SAND CREEK RESTORATION

PUBLIC IMPROVEMENT CONSTRUCTION PLANS

EPC STORMWATER REVIEW COMMENTS ARE SHOWN IN ORANGE BOXES WITH BLACK TEXT

PCD-ENGINEERING REVIEW COMMENTS IN BLUE BOXES WITH BLUE TEXT

RIFFLE TYPICAL SECTION A-A
SCALE: N.T.S.

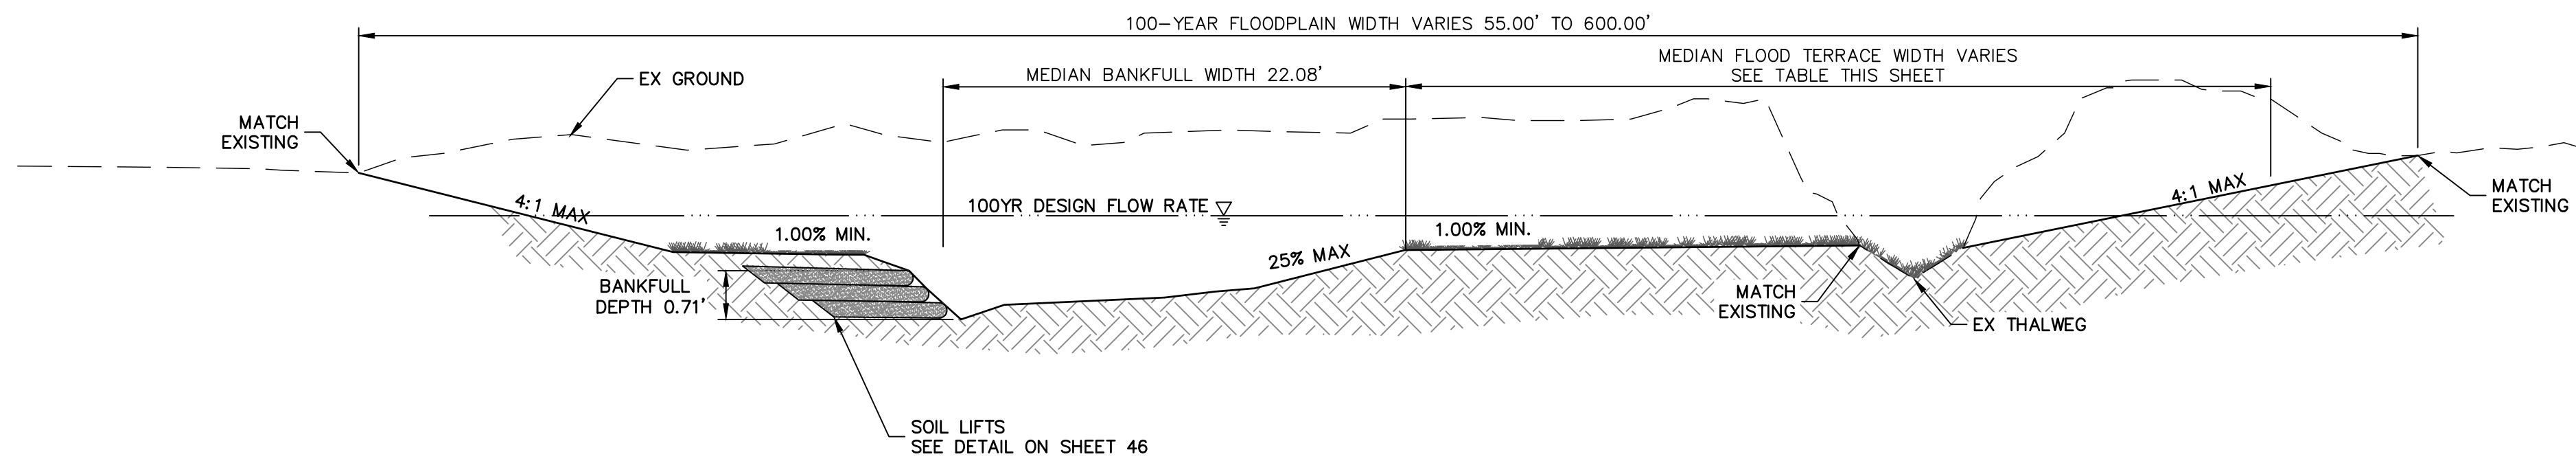
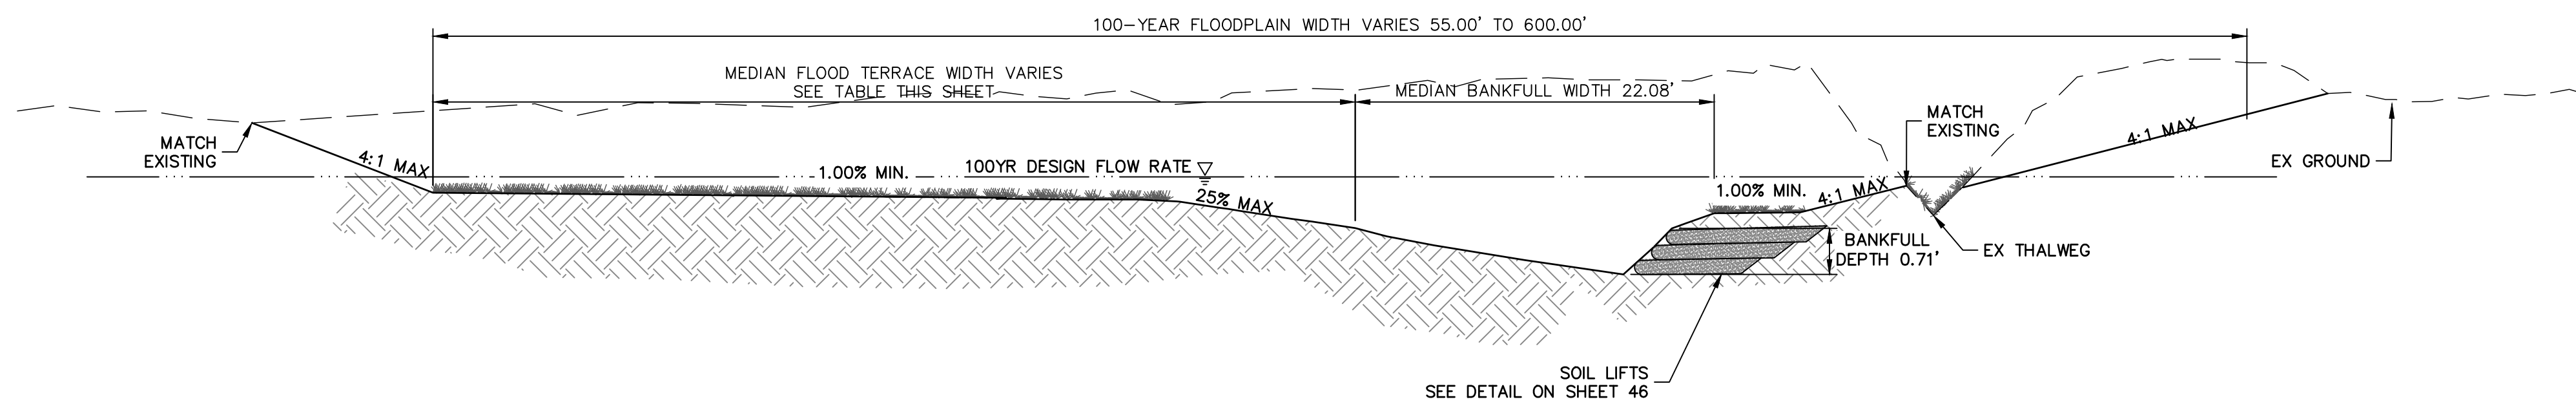
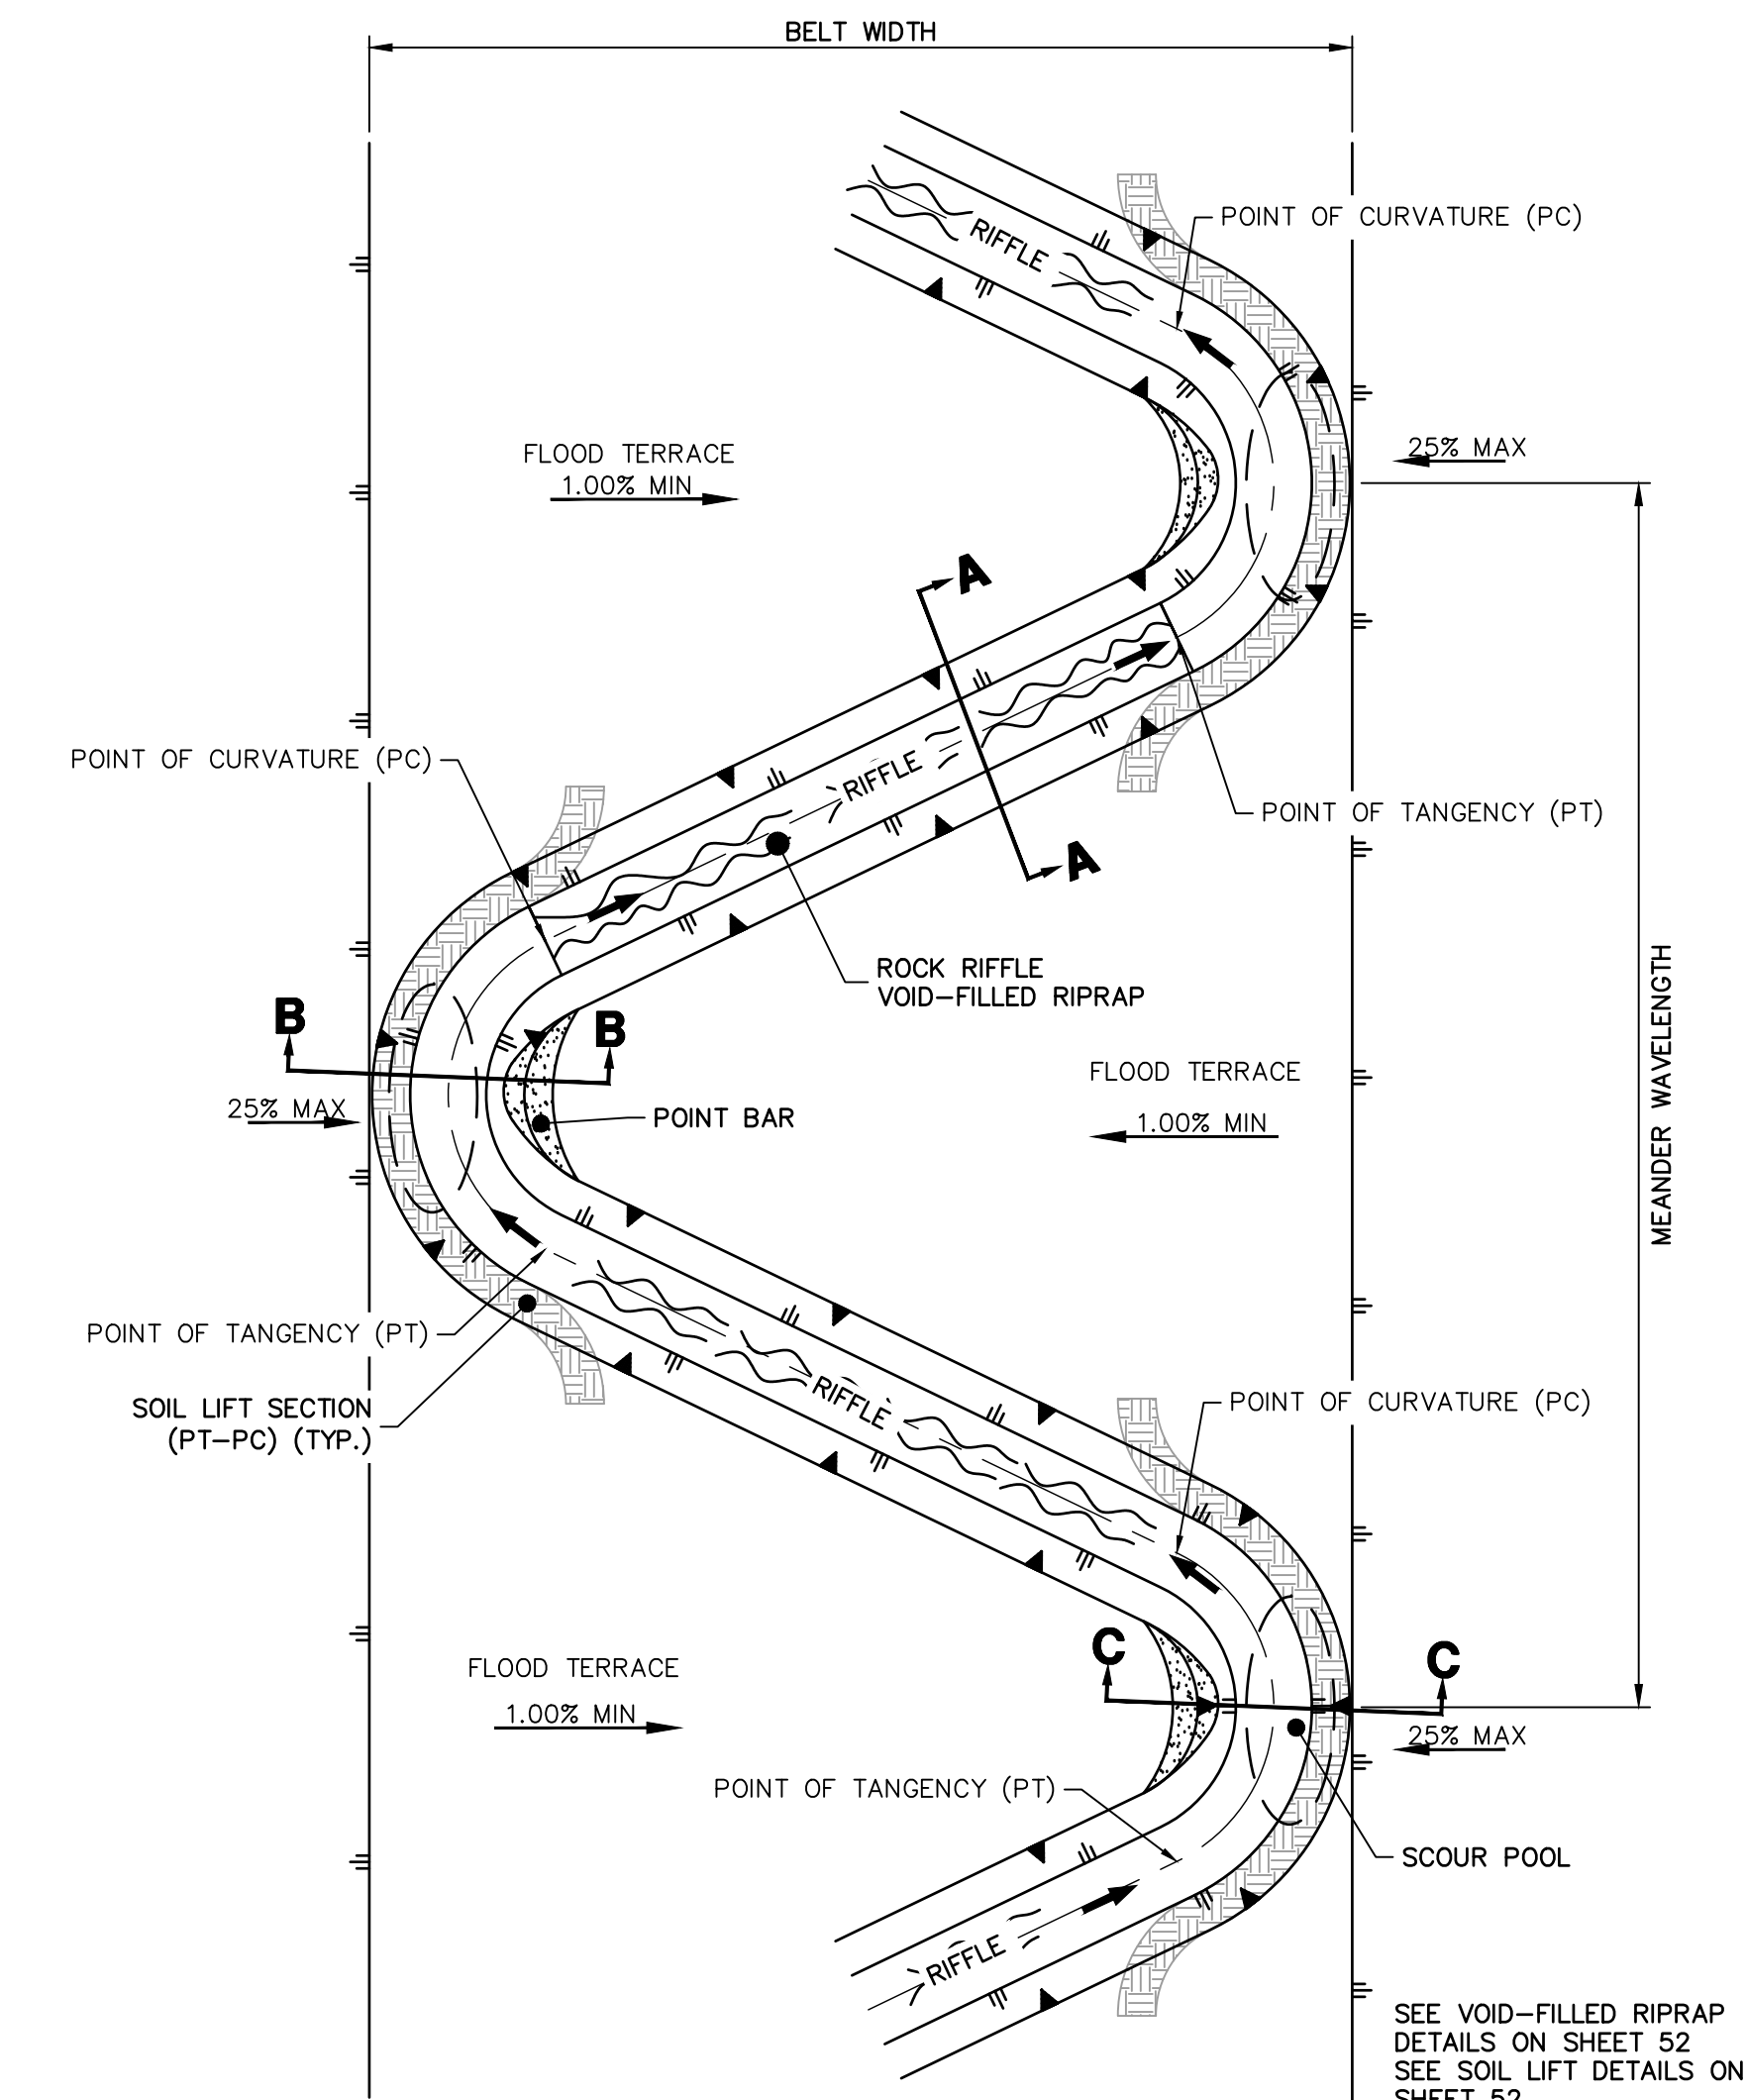
Add a note addressing what is proposed where this is not met

Add Froude No. standard (to be subcritical except at drops/riffles)

Add the capacity of 2, 10, and 100-year flows and criteria used (see drainage report redlines)

**SAND CREEK - BANKFULL PROFILE 2
STA 9+50.00 TO 23+00.00**

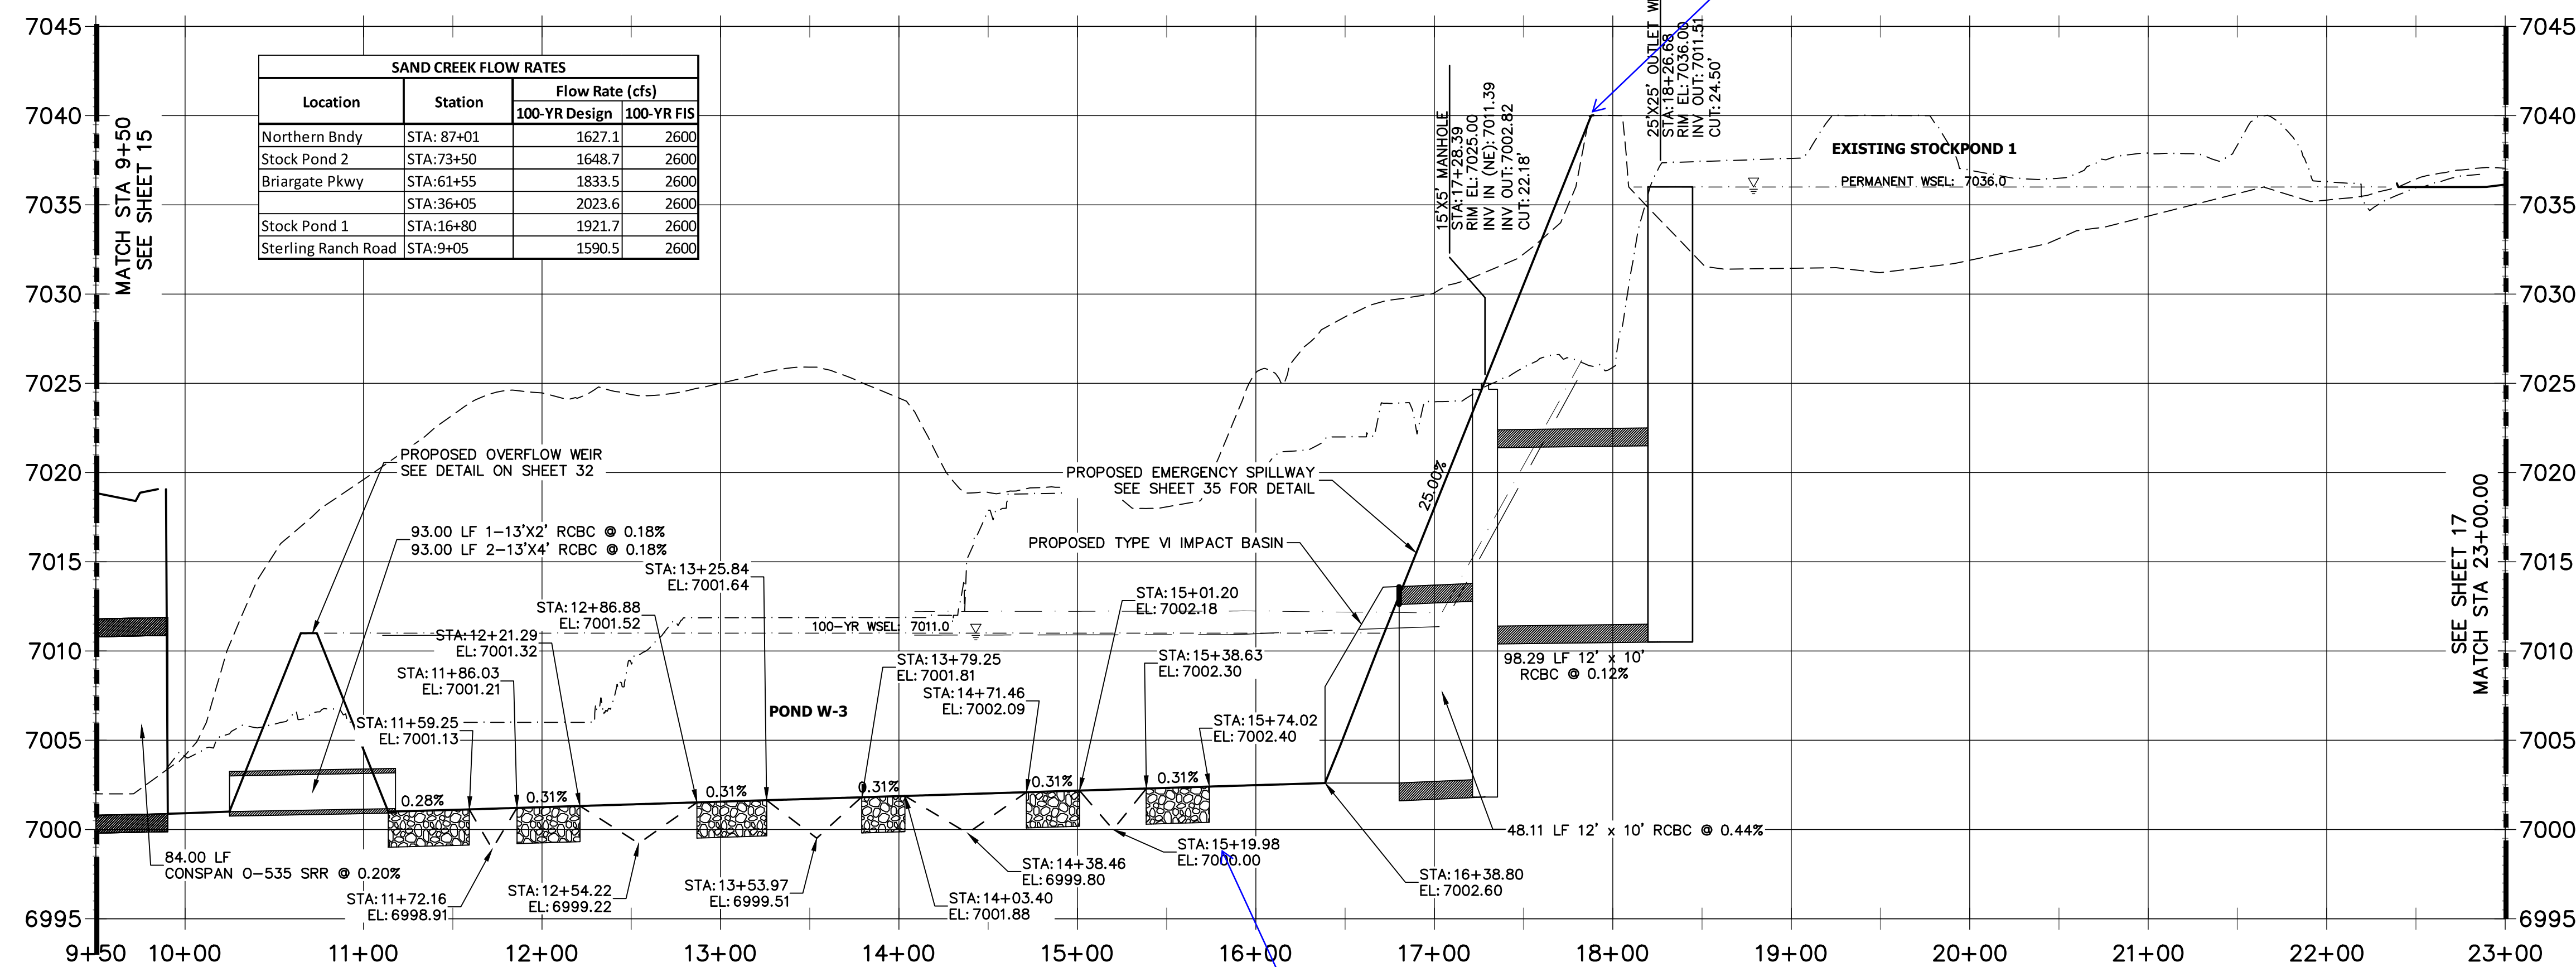
label spillway elev., reference detail sheets

**SAND CREEK - BANKFULL PROFILE 4
STA 36+00.00 TO 53+50.00**

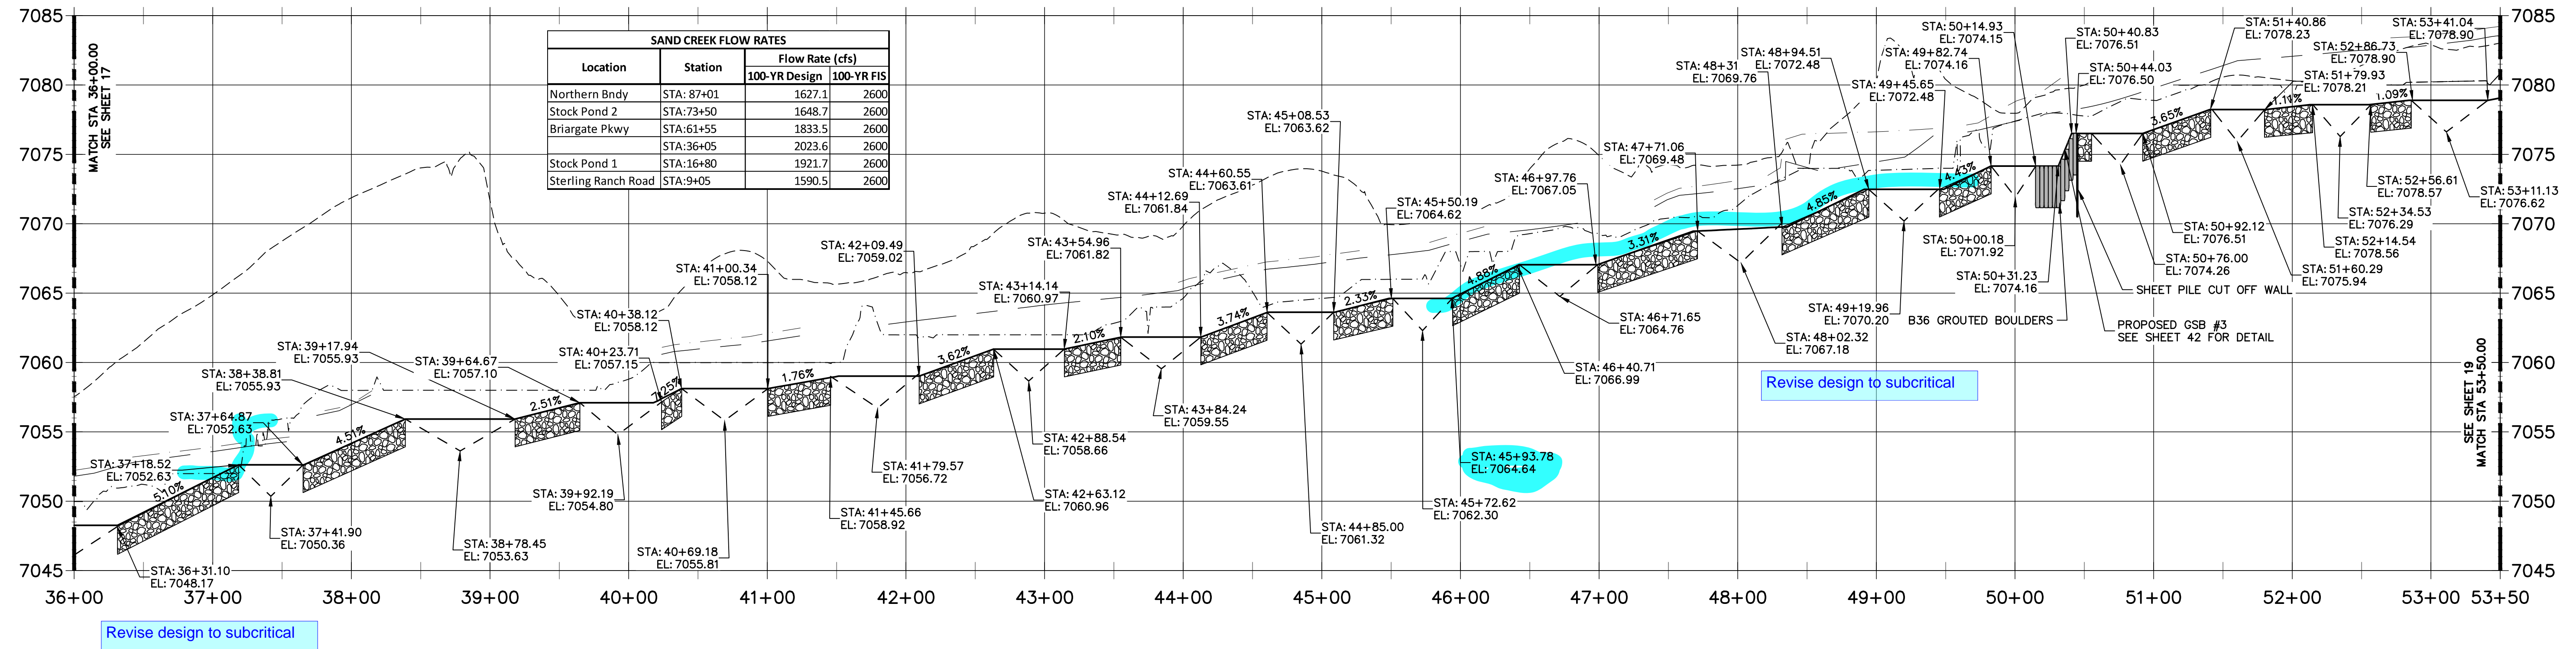
Revise design to subcritical

Revise design to subcritical
